# Staff Report

Re: PLNPCM2020-00451 – *Detached Accessory Dwelling Unit*

**REQUEST:** Alexis Suggs, property owner representative, is requesting Conditional Use approval for an approximate 644 square foot accessory dwelling unit (ADU) above a new detached 3-car garage at the above listed address. The property is zoned R-1/5,000 Single-Family Residential, which requires Conditional Use approval for the construction of an ADU.

SITE PLAN  
A0.3

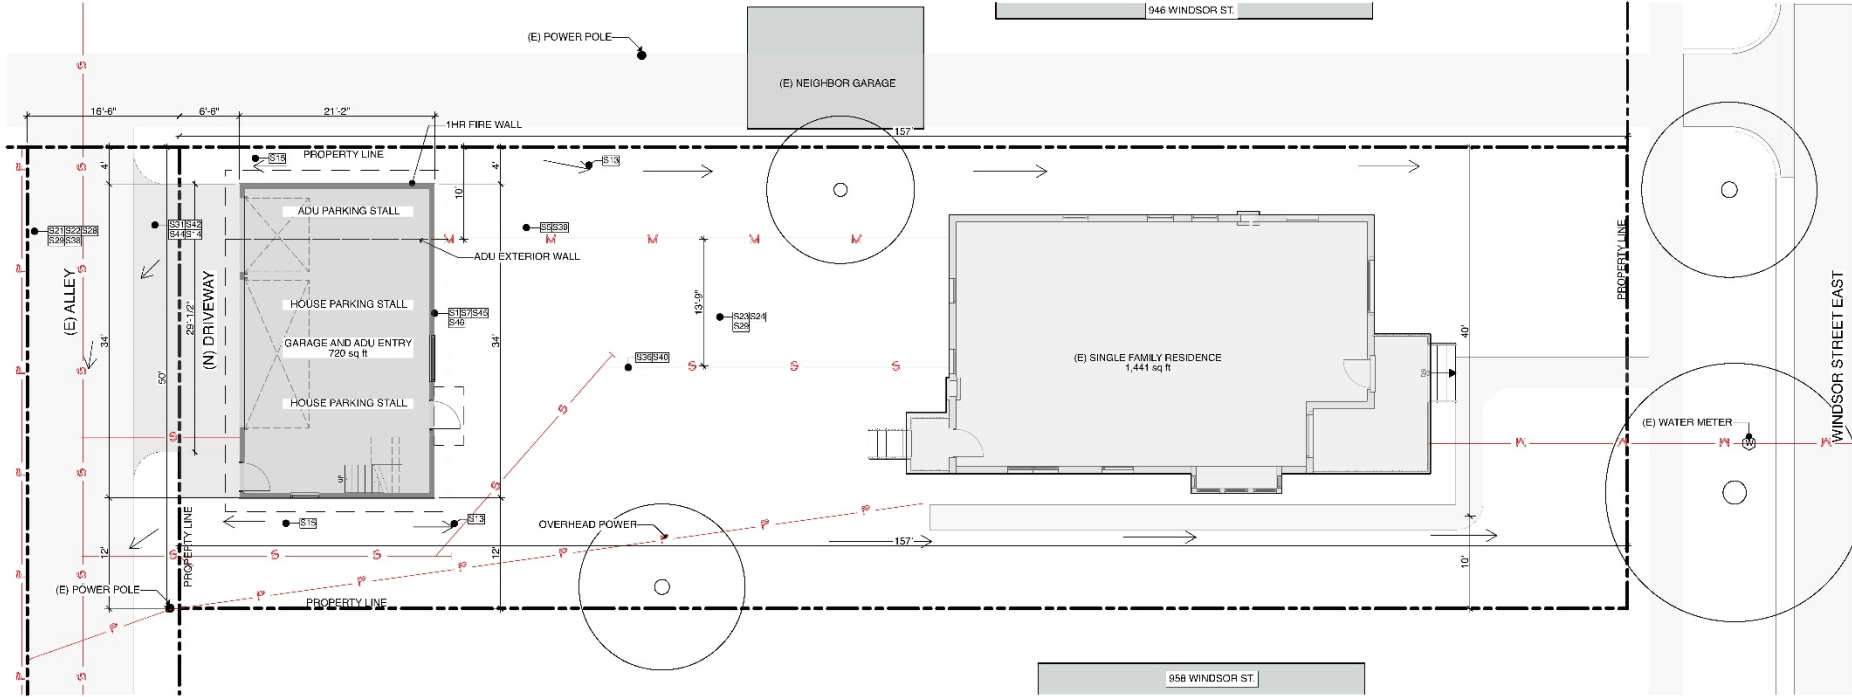
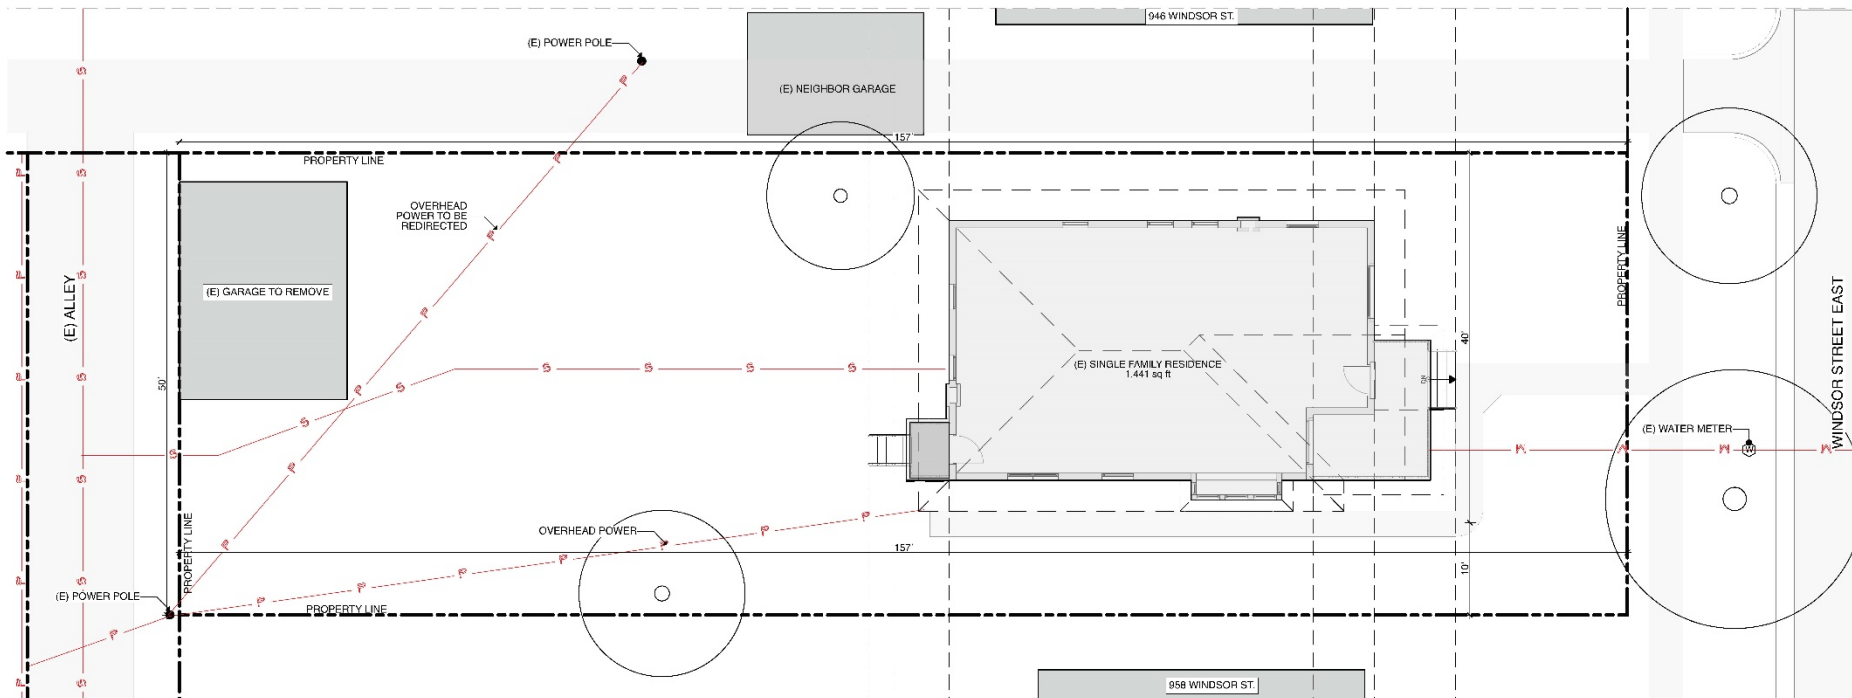
The sewer for the existing home goes out through the back of the house to the alley. To add the ADU, this sewer lateral may need to be moved or replaced. A video of the sewer lateral will most likely be required for reuse.

1. Driveway must show hard surfacing to property line
2. Driveway width must be dimensioned according to section 21A.44.020.F.7.b
3. Entry area + Garage stairs need to be included in the total square footage of the ADU being that they are enclosed & located on the interior of the detached garage (2nd level of ADU = 593 ft.<sup>2</sup>; does that count the stairs & the entry walkway?)
4. Setbacks to the ADU need to be shown in numbers – not lines
5. Please call out the required additional parking stall for ADU

**Planning Staff Notes:** Any additional review will be done during the building permit review phase.

**Planning Staff Note:** The applicant made several revisions to address these comments in their plans attached to this report. A full zoning review will be done during the building permit review phase.

FIRE SITE PLAN  
A0.4

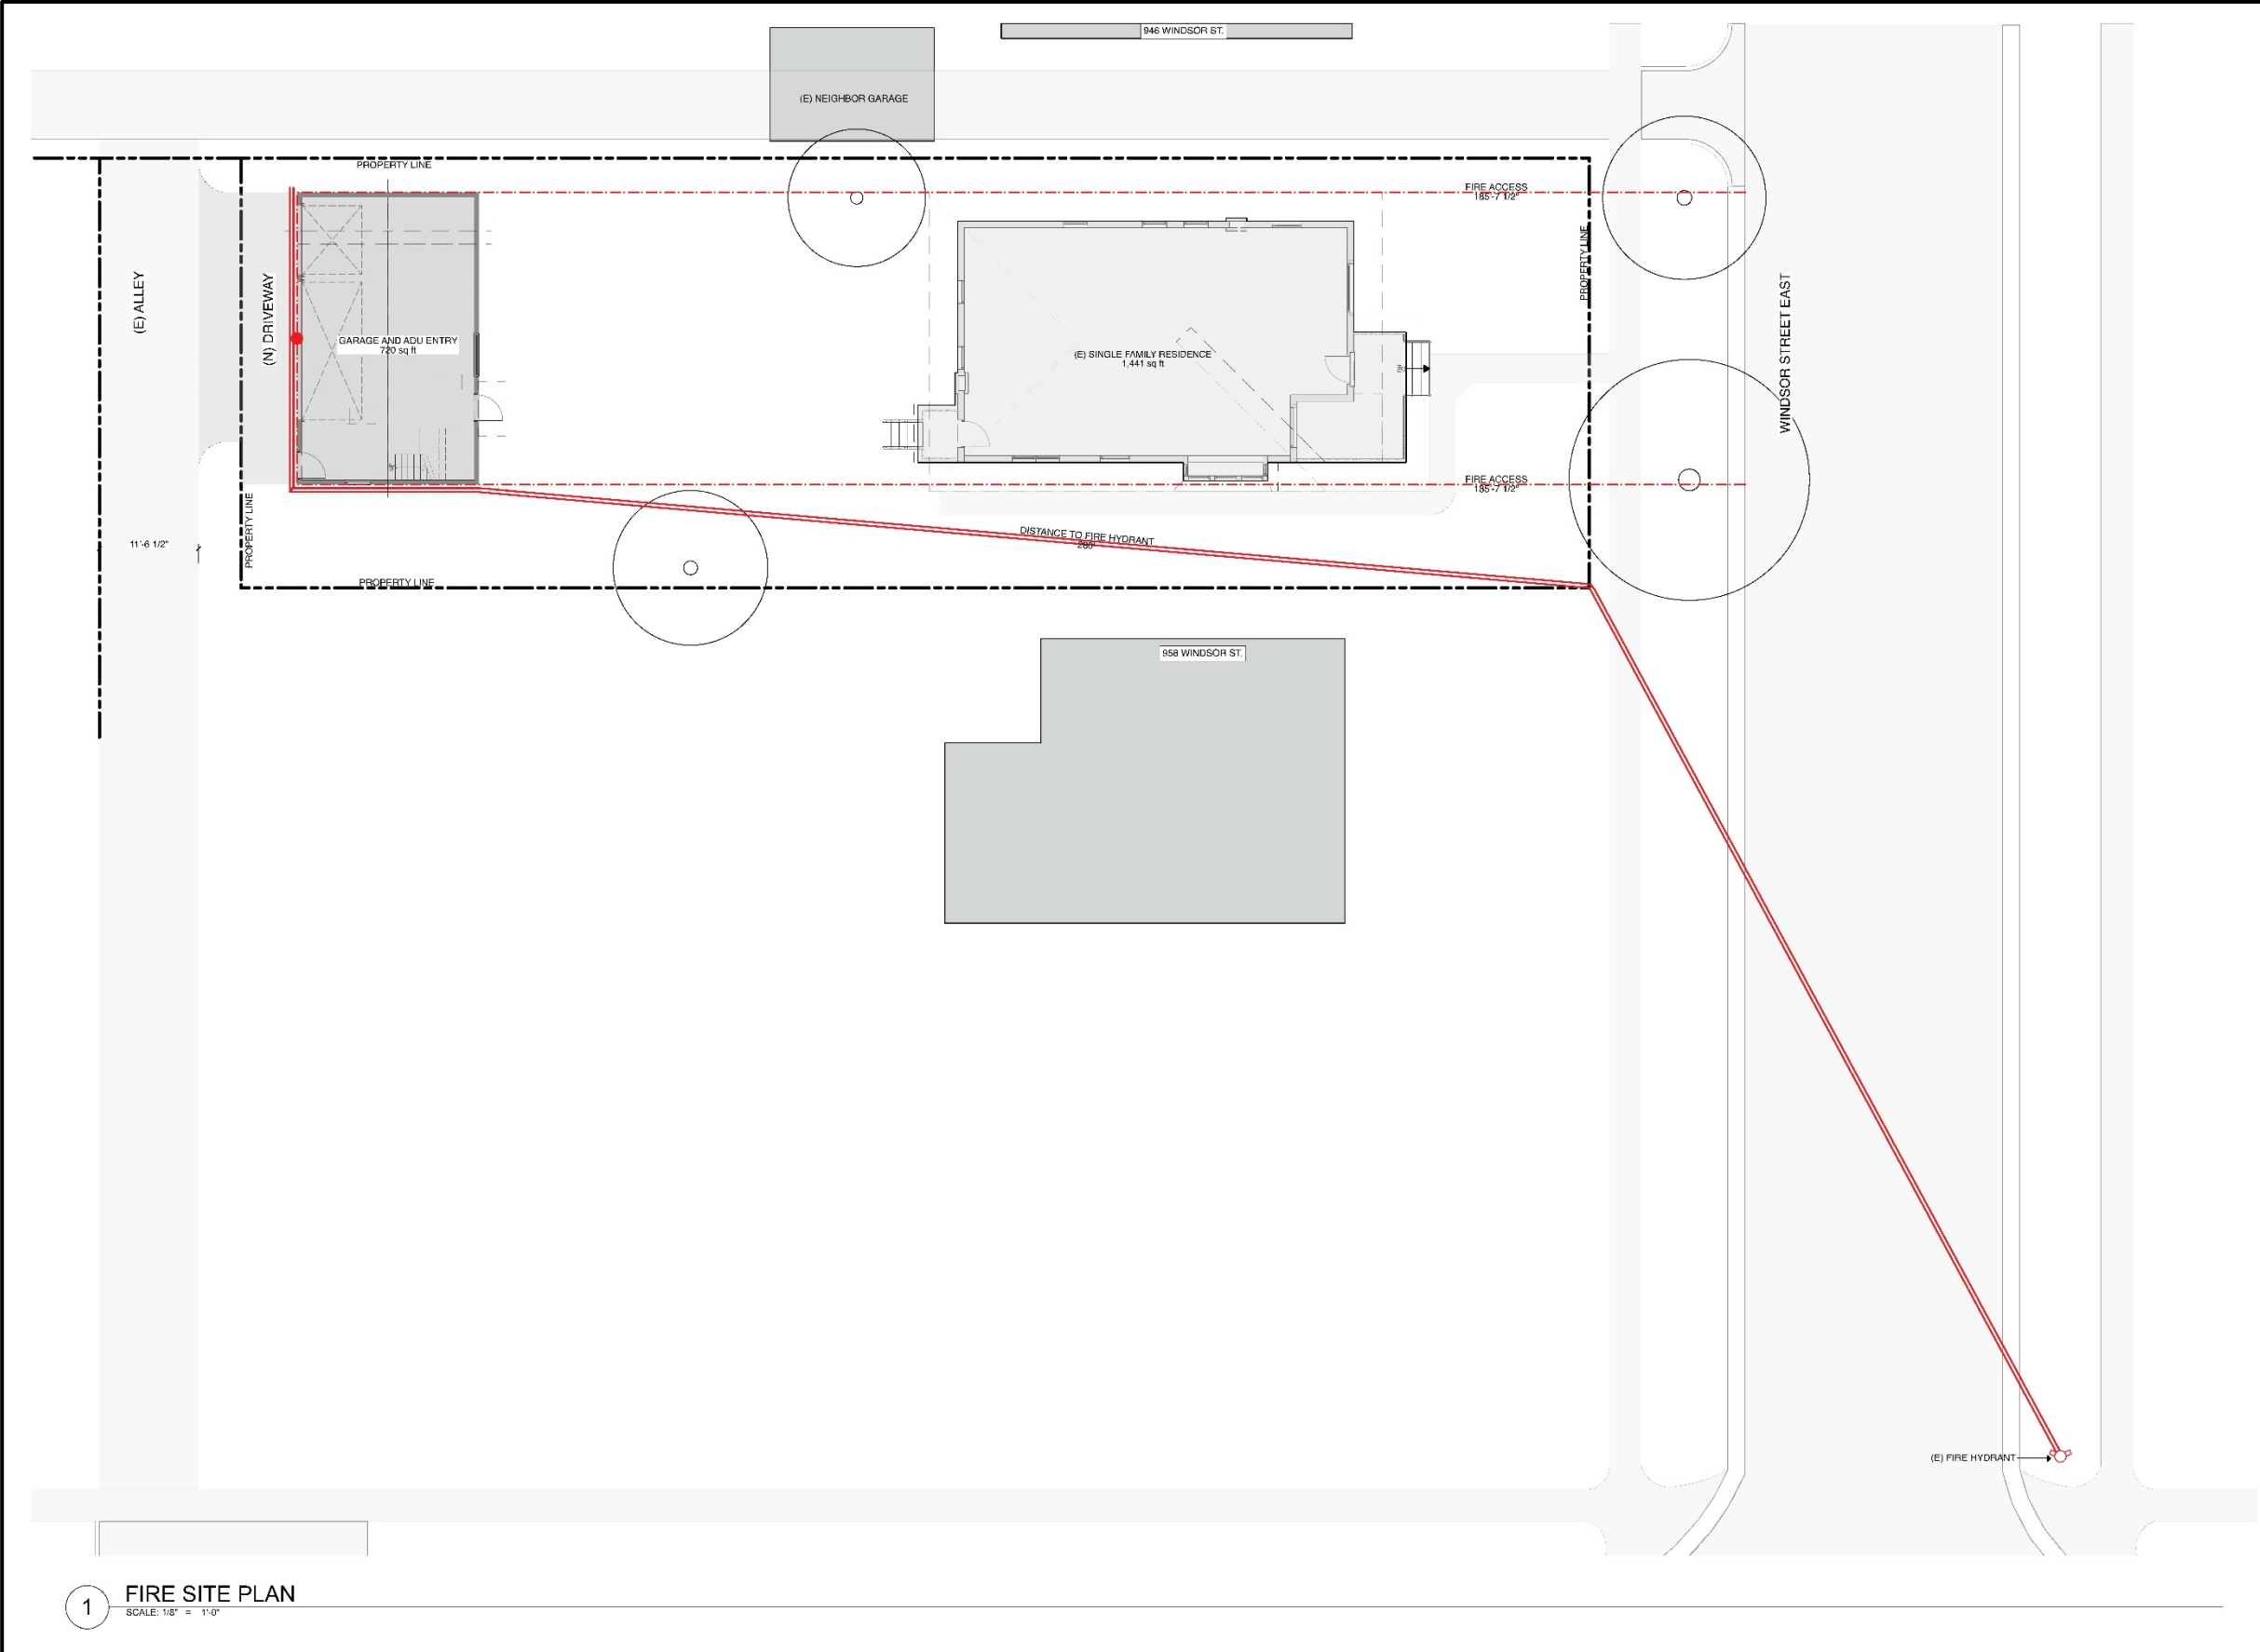
Fire hydrant shall be located within 600-feet of all first story portions of structures on the property. Measurements are made following the drive path from the hydrant and fire access roads around the structures.

Fire access roads shall have a minimum clear width of 20-feet and unobstructed clear height of 13-feet 6-inches.

**Planning Staff Note:** Final compliance review will be done during building permit review phase.
